# 42 Honeysuckle Drive

State Significant Development (SSD-10378)

DEVELOPMENT MODIFICATIONS

March 2022

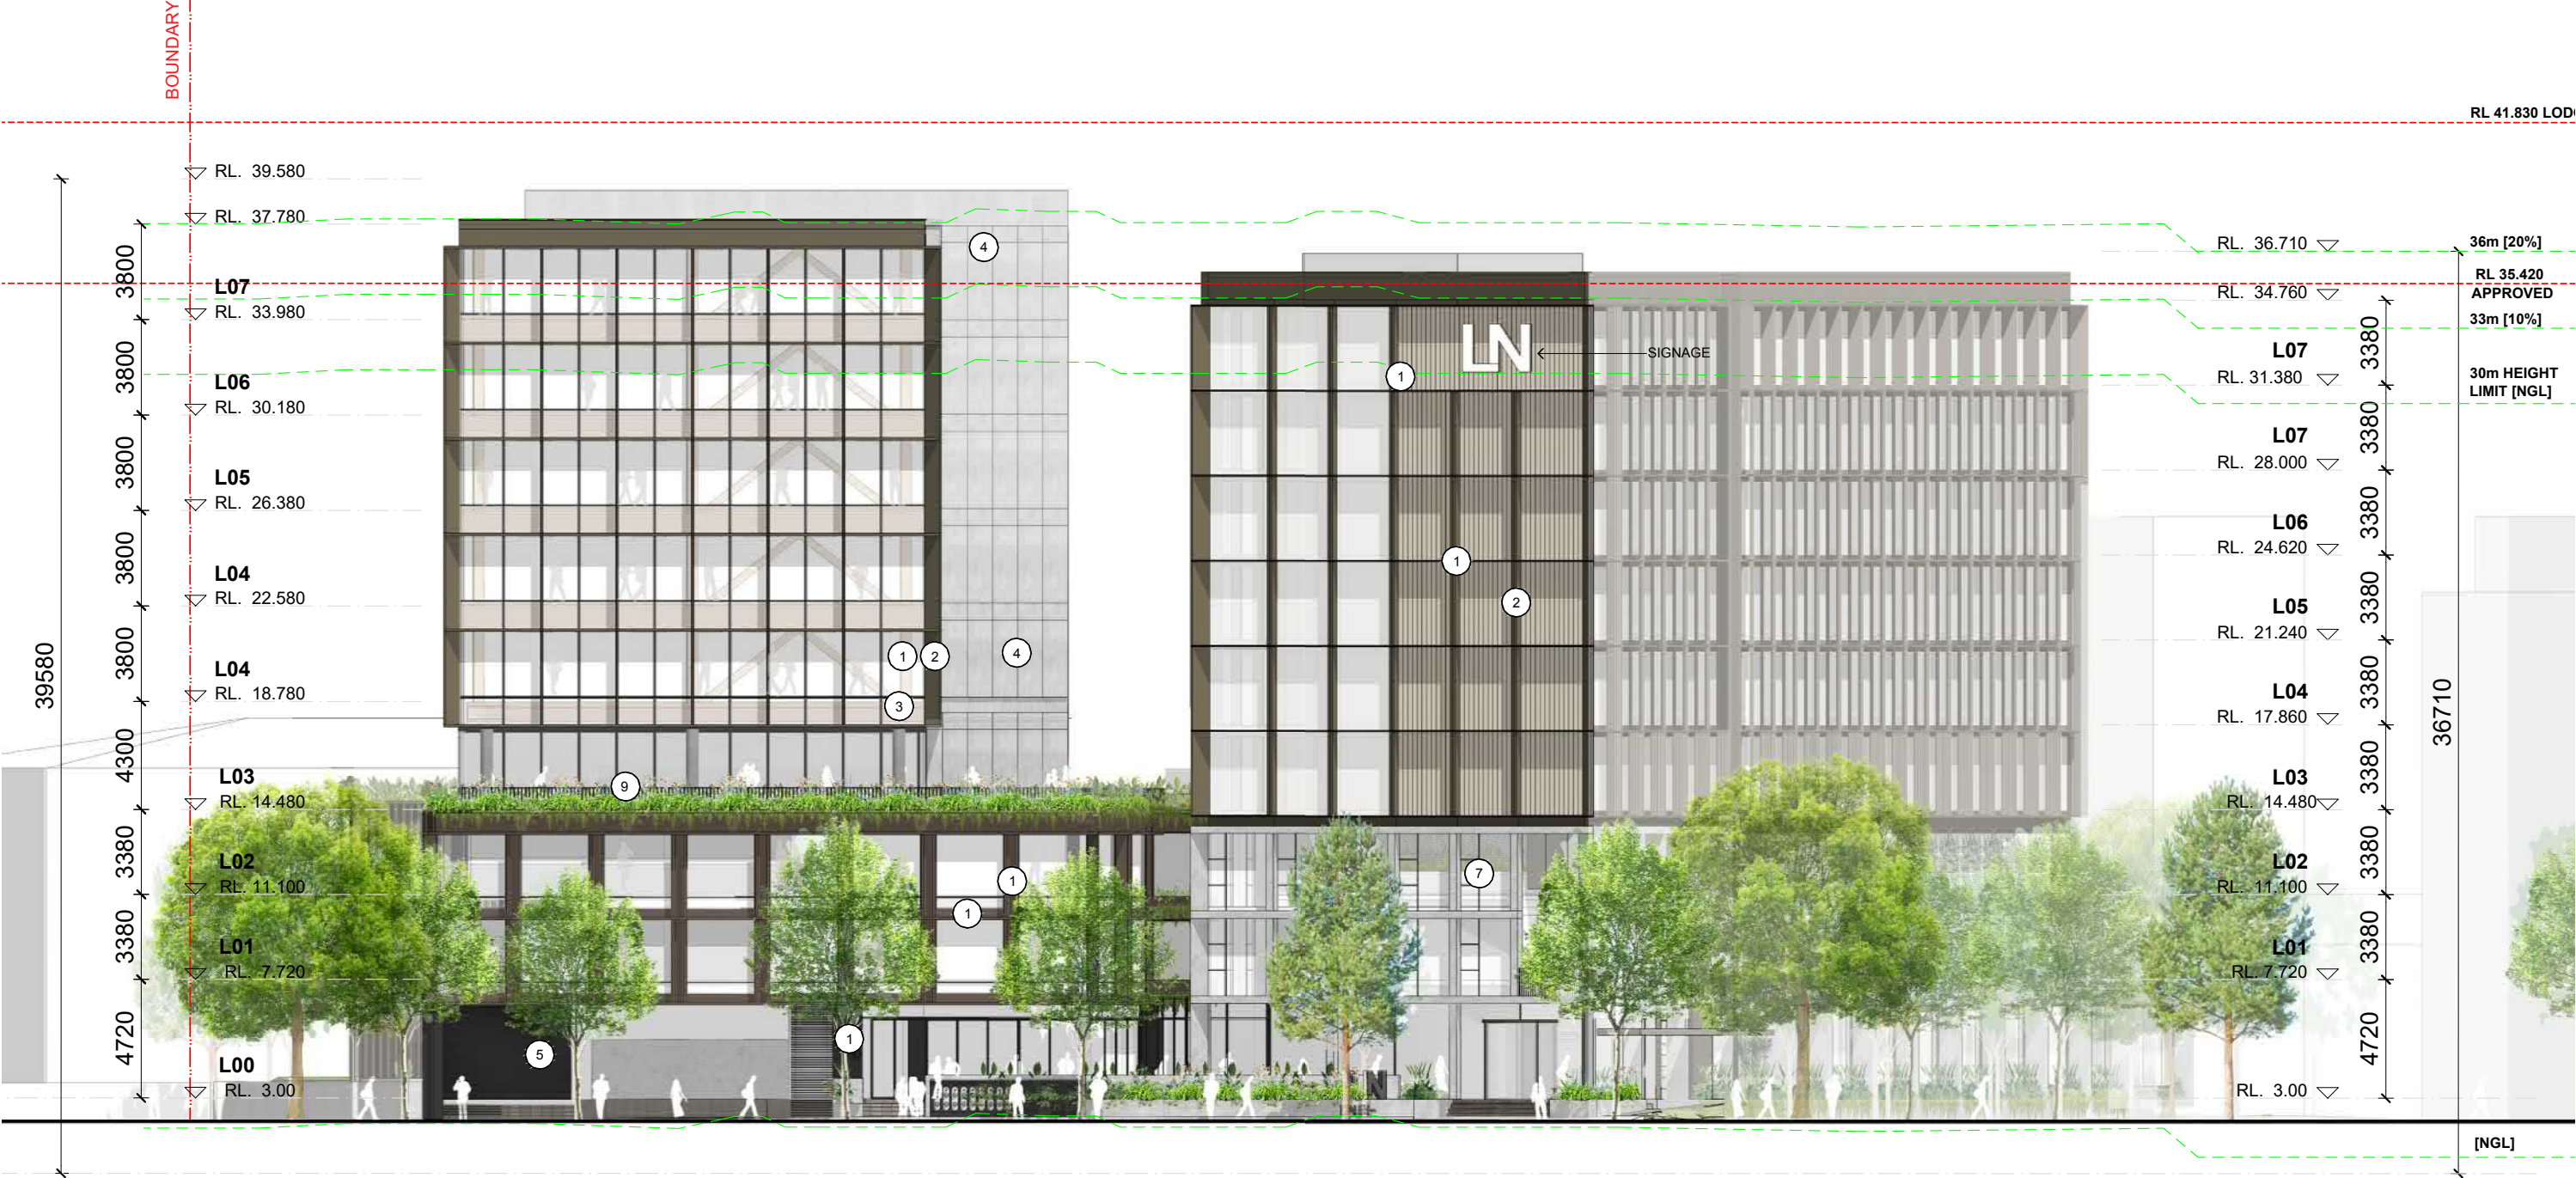
- 1 / South west end of the building at levels L00/L01/ L02 set back from south boundary line.
- 2/ End of trip facility/ meeting rooms/ BOH configuration amended to accommodate a deeper reception space and visibility to carpark/ entry and lift lobby.

- 3 / Hotel entry location shifted including external stair access.
- 4 / Substation location shifted 450mm to the west to align with structural columns above.

- 5 / Commercial entry and location of stair access shifted 450mm to the west.
- 6 / Amenities to commercial floor area shifted and combined with the hotel facilities.

- 7 / Feature stair relocated to the western side of the communal space. Stair links from ground floor to level L02.
- 8 / External western terrace to level L02 off the hotel communal space omitted.

- 9 / Planter between building forms along the Northern elevation at levels L01 and L02 omitted.
- 10 / South west end of the hotel - 1 room from every level omitted.

- 11 / Western hotel facade sun-shading design amended. Louvres removed and 600mm vertical and horizontal fins angled.

- 12/ Landscaped area to the northern terrace increased.
- 13 / Facade amended outside lift lobby. This is now concrete construction rather than glazing to increase privacy between the hotel and commercial tower.

- 14 / Commercial tower external plant space increased in size
- 15 / Fire stair from commercial tower and hotel extended to roof access.
- 16 / Hotel slab to slab levels reduced from 3380mm down to 3100mm. This has resulted in an overall hotel building height reduction..

- 17 / Commercial tower height increased by 600mm to allow for additional plant height
- 18 / L01 and L02 North/west corner amended. External terrace omitted and sun-shading added to level L02

- 19 / Arbor structure has been pulled back at the south boundary.
- 20 / Loss of 2 parking bays per level L01 and L02, commensurate with the reduction of GA and increase in motorbike spaces

- 21/ Facade colours and materiality generally the same with the exception of the western facade and the hotel north and south elevations that now has a darker finish.

- 22 / External fire tank to south elevation

# 2.1 Design Changes North Elevation

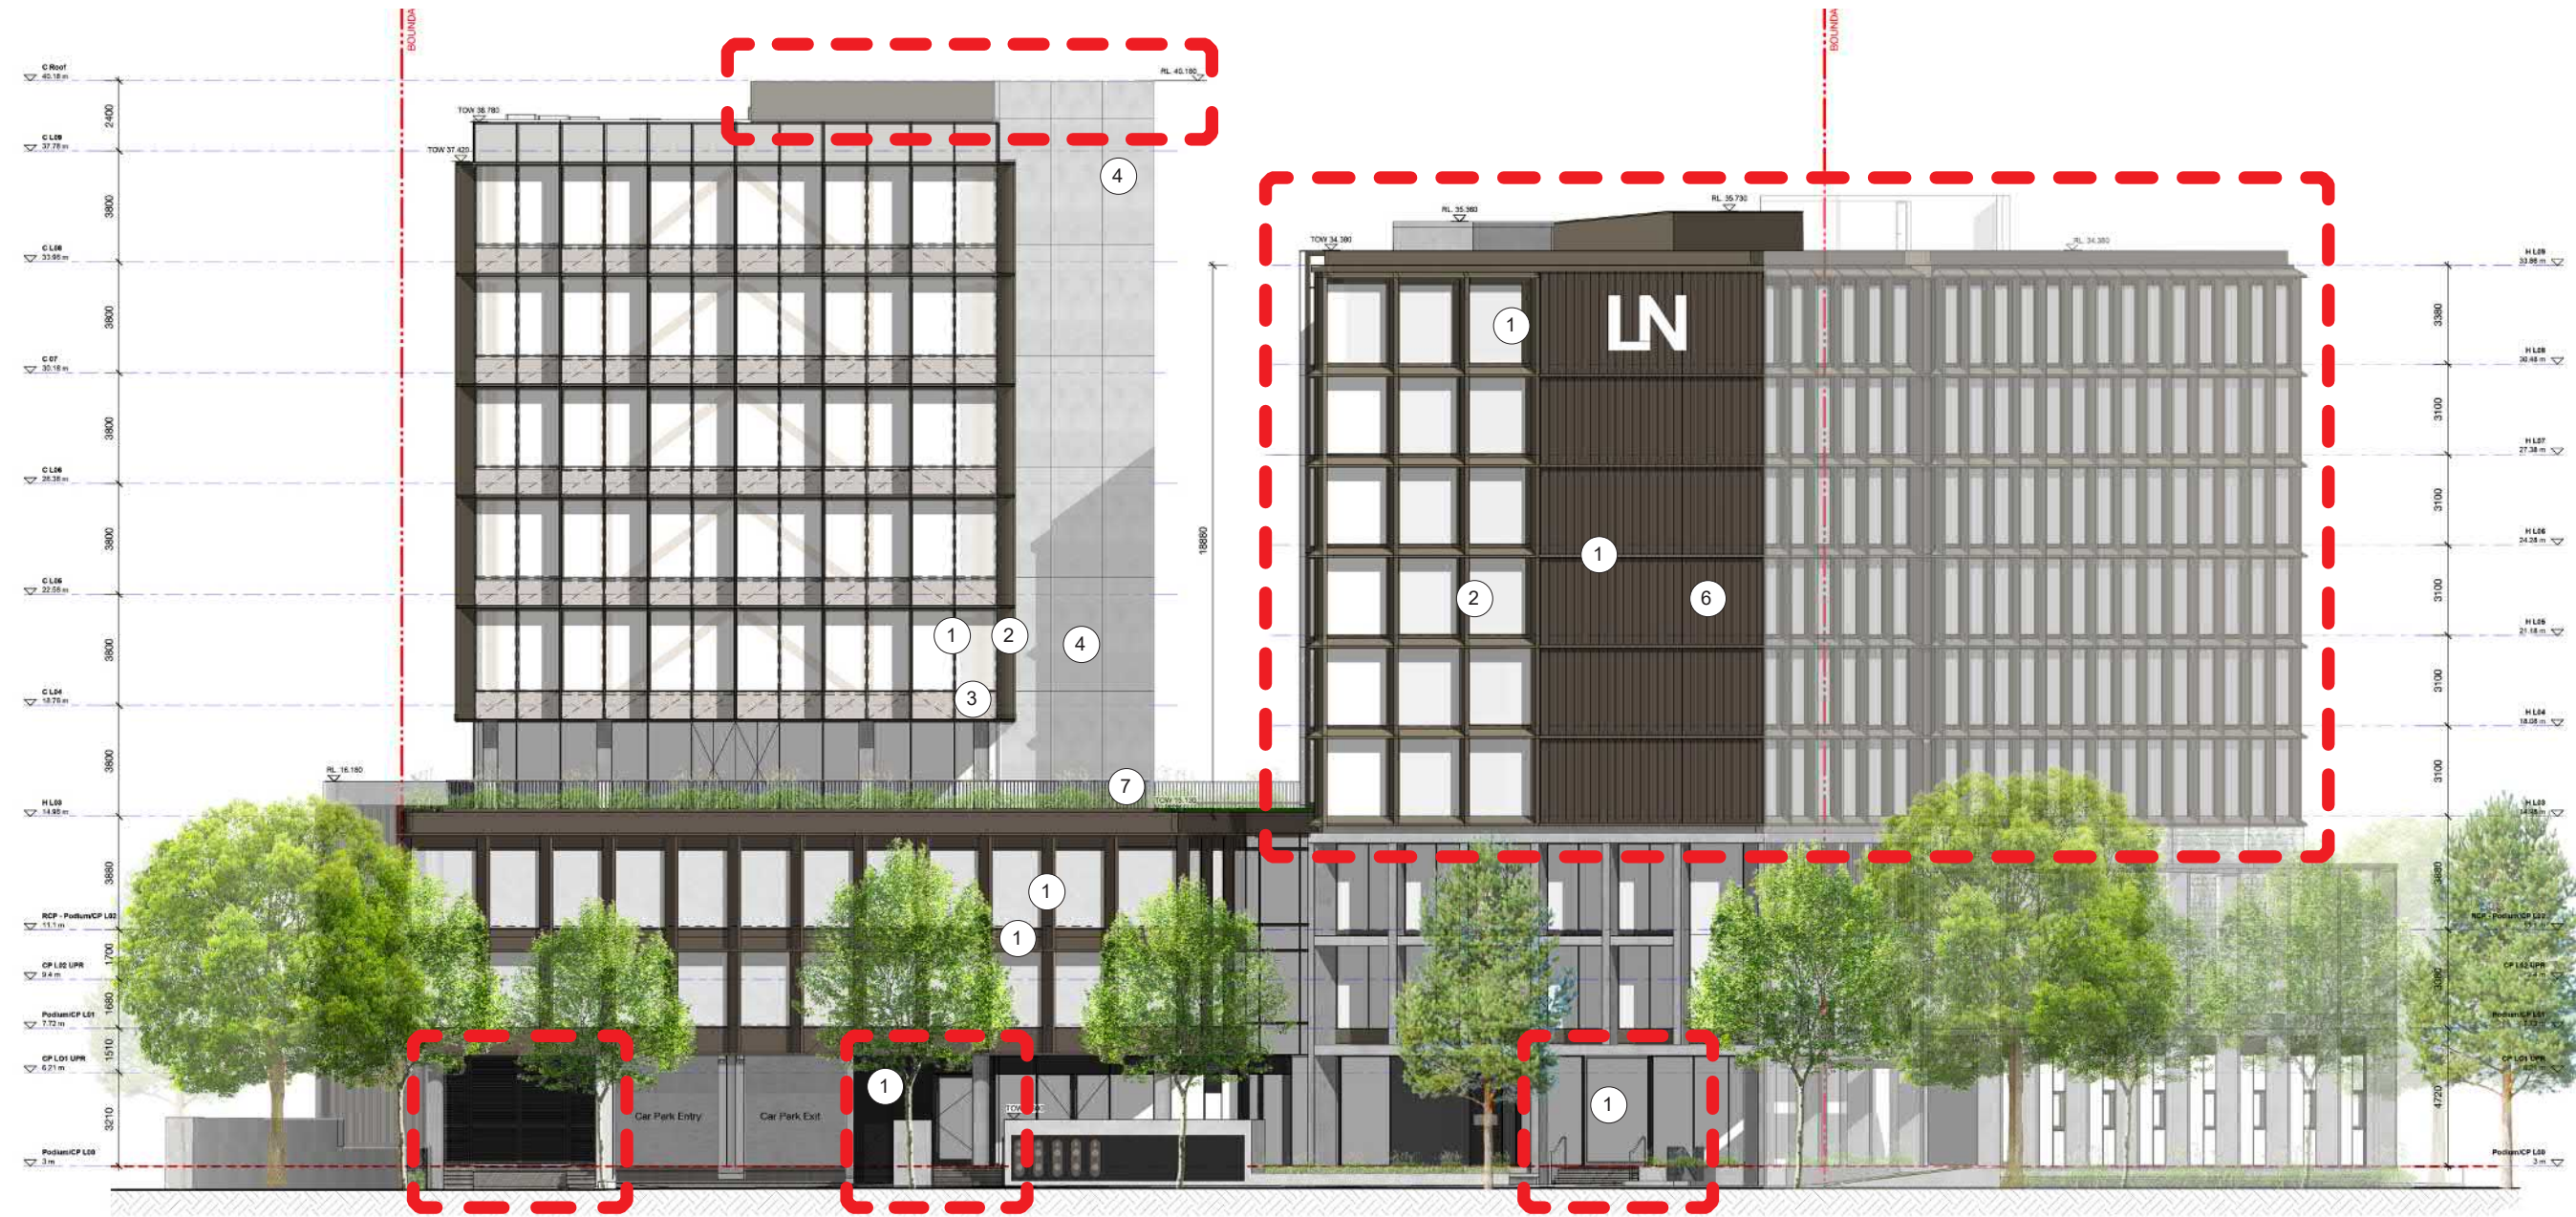
- 1 / Substation location shifted to align with structure over
- 2 / Commercial lobby and associated external access stairs shifted
- 3 / Hotel entry and associated external access stairs shifted
- 4 / Hotel slab to slab levels reduced from 3380mm down to 3100mm. This has resulted in an overall hotel building

- Height reduction.
- 5 / Commercial tower height increased by 600mm to allow for additional plant height
- 6/ Facade materiality remains the same with the exception of the north facade of the hotel facade - some of the fenestration has been removed and the colour moved to a dark bronze..
